**NOTICE OF INTENT TO COMMENCE LARGE MINING OPERATIONS &  
MODIFICATION OF PLAN OF OPERATIONS**

**LISBON VALLEY COPPER MINE**

M/037/0088

**Introduction Table 1 – Comments**

Post Reclamation Hydrology - Leach Pad

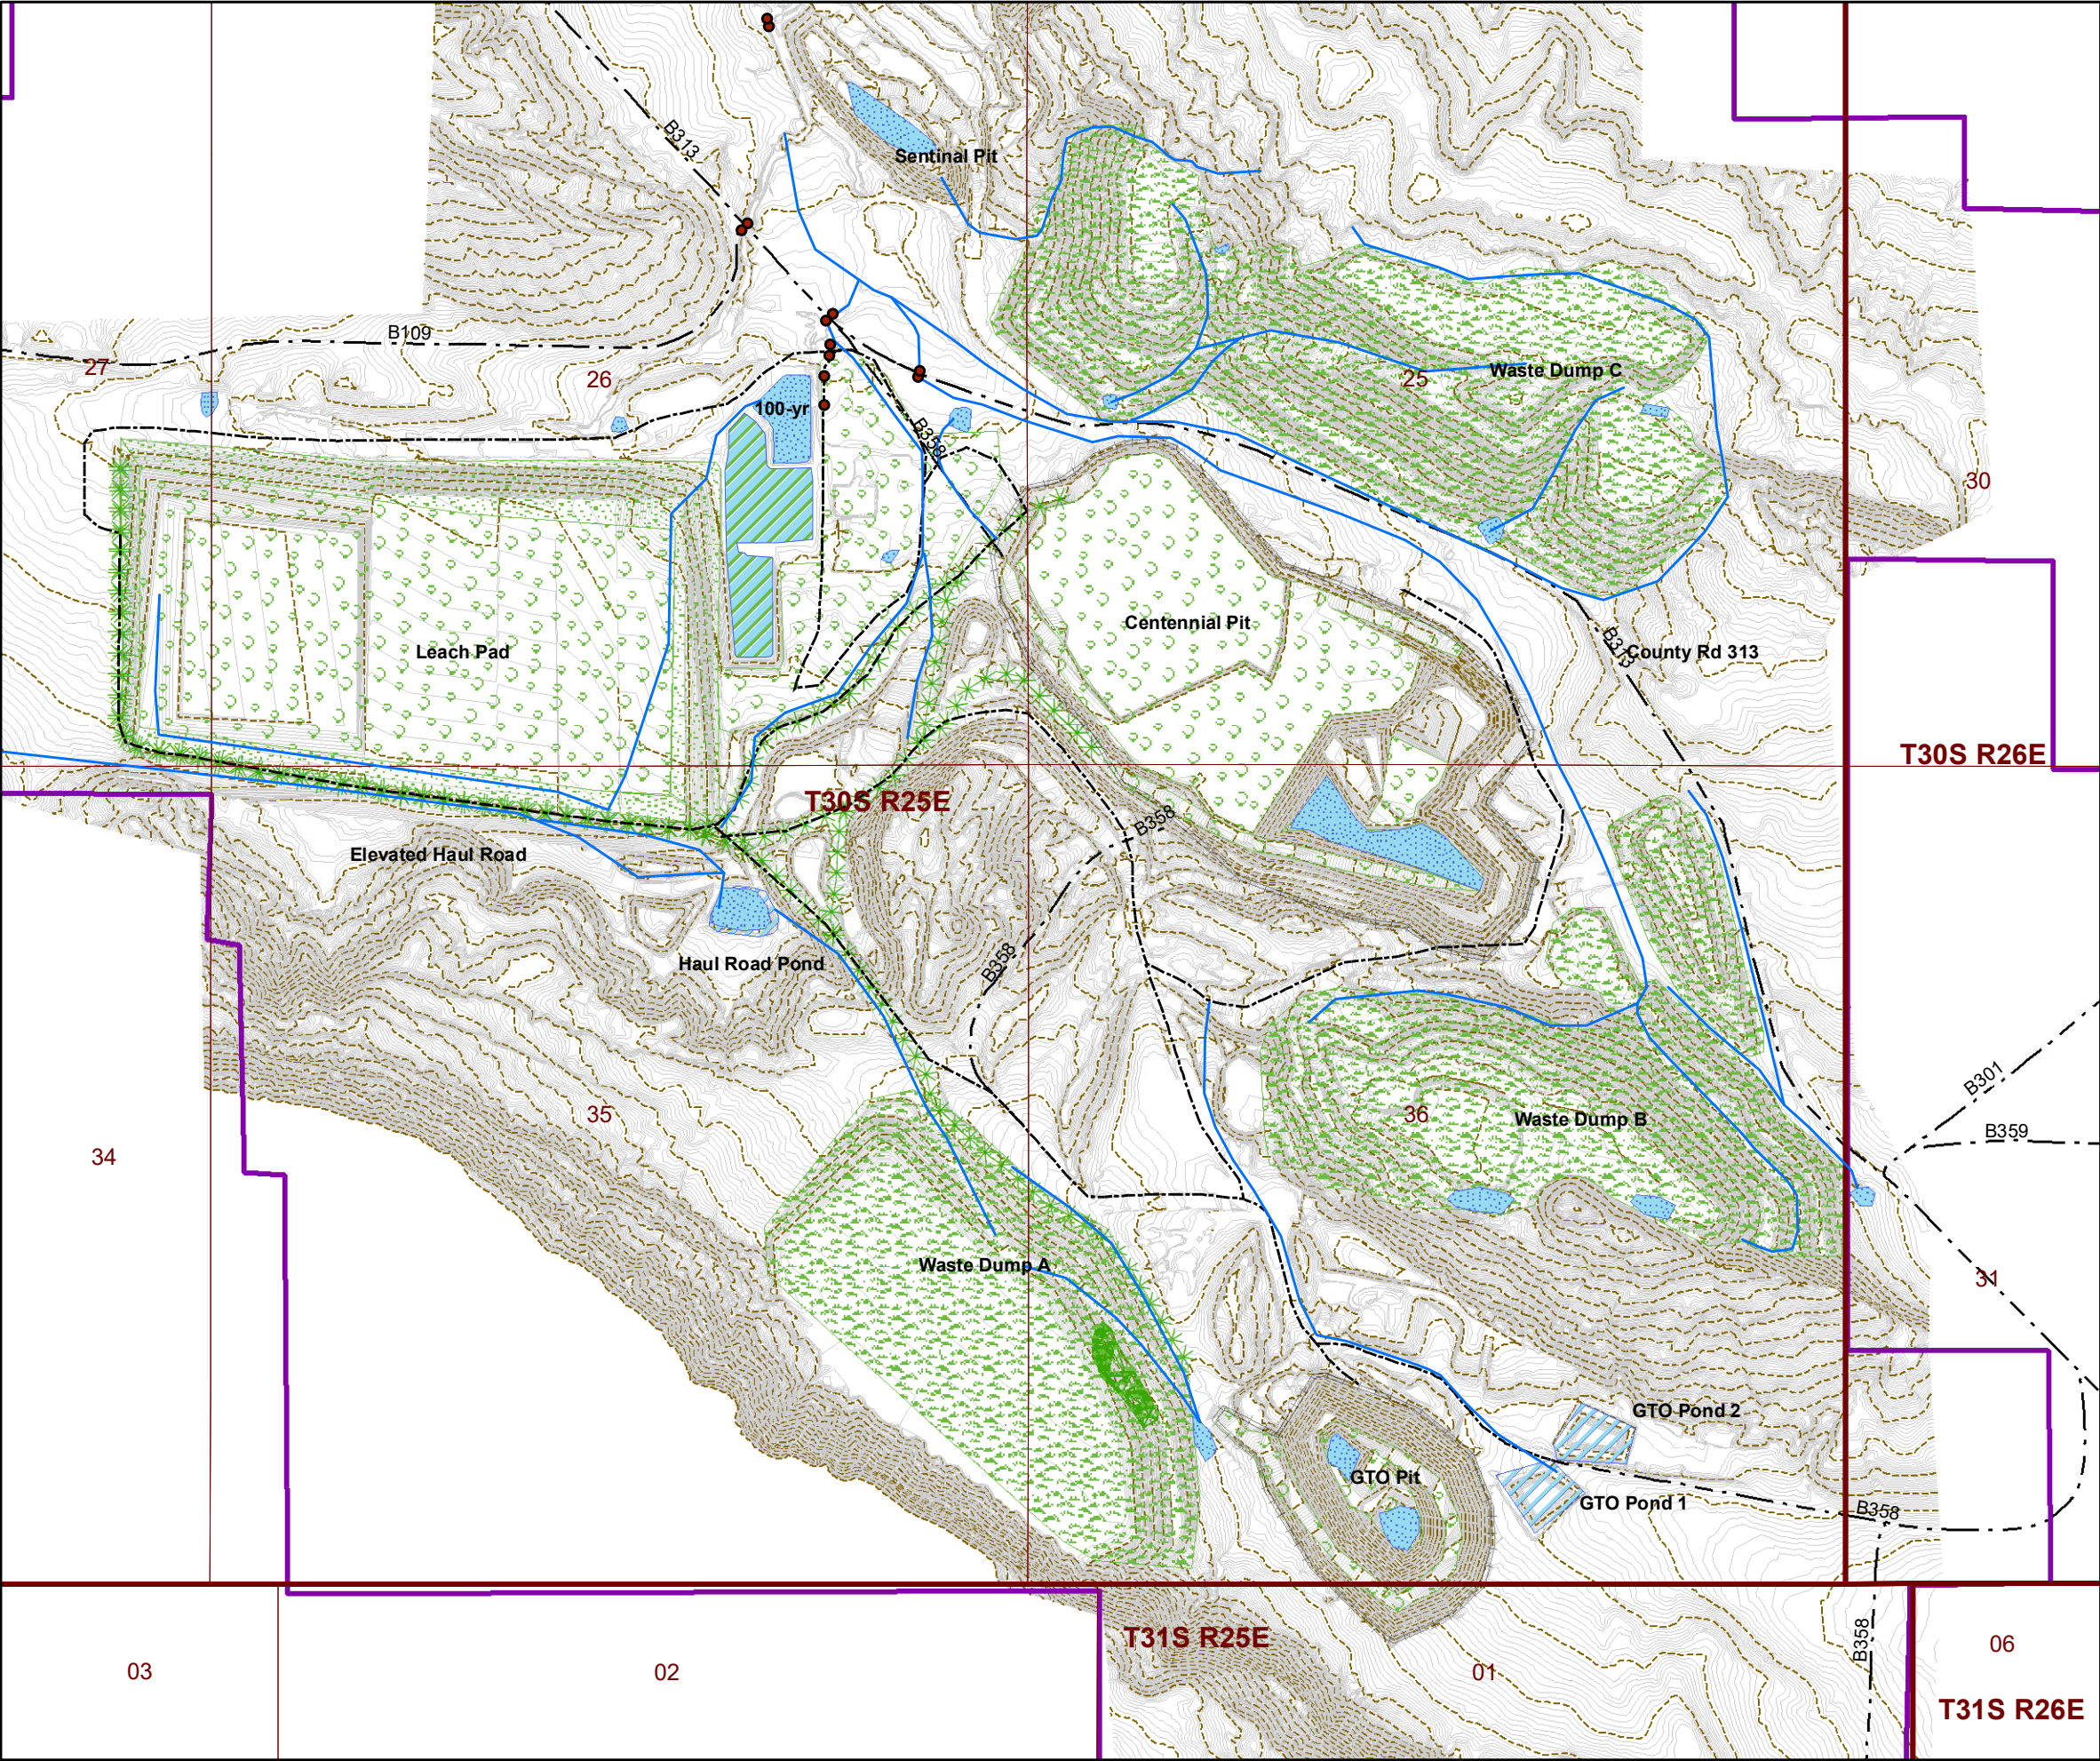
UDOGM Comment	Company Response	Response Location
Map 4, Hydrology – A new Map 4 has not yet been provided. As indicated in previous reviews, the existing Dump C channels are not acceptable in their current form. Watershed boundaries and associated acres are not included in previous maps. GTO areas planned for disturbance that may affect the grade and stormwater flow should be included within disturbance boundaries on this and other maps.	Map 4 has been updated to include the hydrologic features per the aerial flights and drainage processing performed by LVMC in February 2020. Modified drainage patterns have been mapped out for installation of riprapped drainage channels and associated catchment basins.	Appendix C
<p>Map 5, Reclamation Treatments (all maps) – Consistent with the discussion in section 110 (reclamation plan), include the following:</p> <ol style="list-style-type: none"> <li>1) Identify berms around pit highwalls (not just at access points), as requested above. Fencing alone is not considered adequate for long-term public safety.</li> <li>2) Indicate whether pond HDPE liner will be removed or modified (including to receive any graded heap leach pad slopes)</li> <li>3) Identify the depths of soil replacement, as well as compacted clay and inert waste rock thickness on the heap.</li> <li>4) Identify soil replacement on haul roads. Ripping alone is not likely to be successful since the roads probably contain contaminants that would inhibit vegetation.</li> <li>5) The Division recommends a single ripping of spread soil on the contours, since dozer track marks from grading are less likely to resist erosion over slope lengths such as these.</li> <li>6) Indicate that the landfill will be reclaimed consistent with Department of Environmental Quality (DEQ) requirements.</li> </ol>	<ol style="list-style-type: none"> <li>1) Berms have been identified around all pit perimeters. These are seen on the modified Map 5, Appendix C.</li> <li>2) Pond liner already ties into the leach pad liner via the east drainage ditch. No liner modifications are required for the ponds to receive graded leach pad slopes. Regarding the areas on the north where the slopes are not yet 2.5H:1V, these slopes are to be re-graded in 2021 in preparation for another lift. Although current leach pad slopes do show some areas that are not operationally 2.5H:1V, all slopes on the leach pad are capable of being re-graded to an overall 2.5H:1V slope when taking into account the pipe ditch at the toe of the pad slopes.</li> <li>3) Please see Map 5 for reclamation media layers.</li> <li>4) Please see Map 5 for reclamation media layers. Placement of topsoil on haul roads will only be performed if excess topsoil is available and if the roads do not serve a post-mine land use. Further, as the roads at the mine have not been treated with surfactants, very low risk of ‘contaminants’ exist on the roads, as all vehicle maintenance is performed at the designated Truck Shop.</li> <li>5) This is noted. Please see notes on Map 5 for reclamation practices.</li> <li>6) This language is located in Section 110 as well as on Map 5.</li> </ol>	Appendix C Section 110 Appendix I

MAP 5

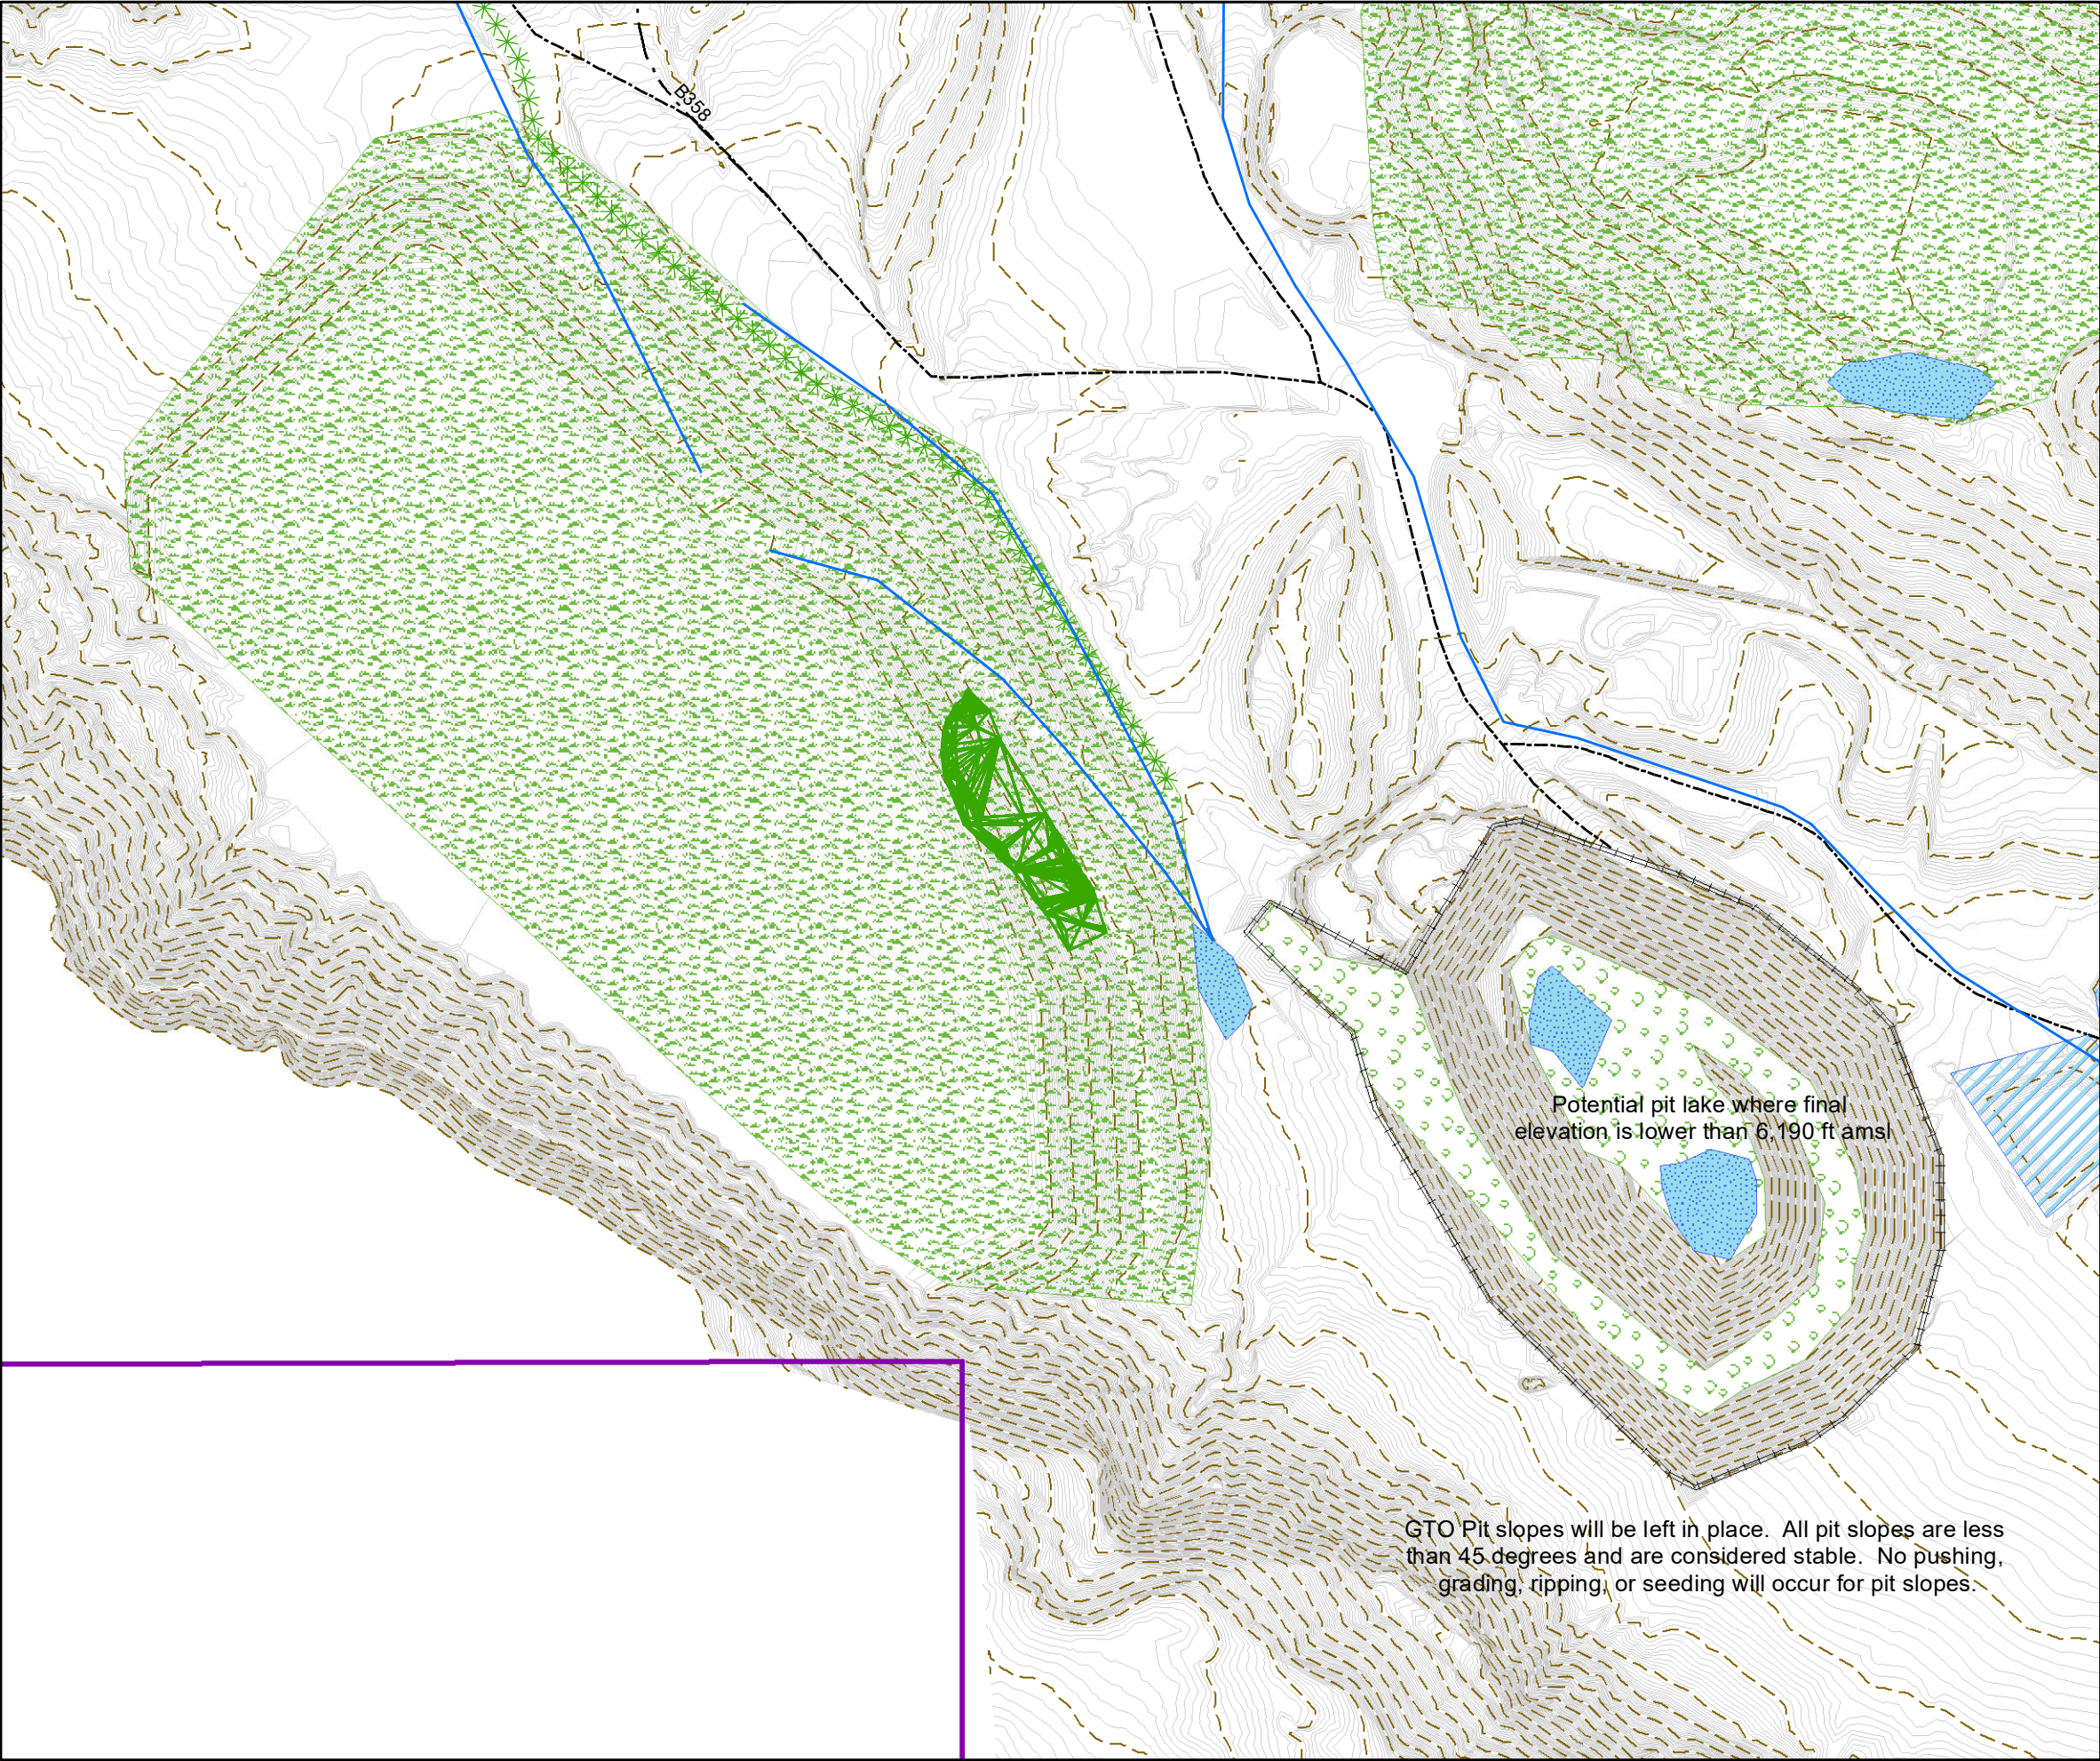
Map 5h, Facilities Map, Truck Shop – Clarify where the Acid Storage is, identify the feature identified as Acid Storage, and change the direct reference to the explosives silo to be less specific about its contents.	The ‘Acid Storage’ was a mis-label. This has been corrected. Please see the updated Map 2.	Appendix C
Based on the Division’s analyses of as-built conditions (elevations collected with a drone), some slopes exist that are steeper than 2.5H:1V, and additional grading of slopes will be required. Update the text as needed. As-built pre-reclamation slope angles affect the reclamation cost estimate and surety amount.	The text has been updated to call out that there still exists operational slopes that may be steeper than 2.5H:1V. The grading plan has been performed using the drone imagery from March 2020.	Throughout Appendix N Appendix I
Based on past experience at the site and landscape design principles, discuss the suitability of the reclamation slope angles on the heap leach piles and waste rock dumps to minimize erosion. Consider whether the slope lengths, particle sizes, and other factors may justify alternative measures.	This is noted. Waste Dump A & B: the overall slope lengths will be broken up by catchment benches to prevent terminal velocity of rainwater runoff to occur. For Waste Dump C, the up-gradient riprapped channels will capture most of the intercepting waters. The water the does fall will continue to follow the set course, with the modification of the drainage channels per Map 5. This language is located in Section 110, as well as on Map 5.	Section 110 Appendix C
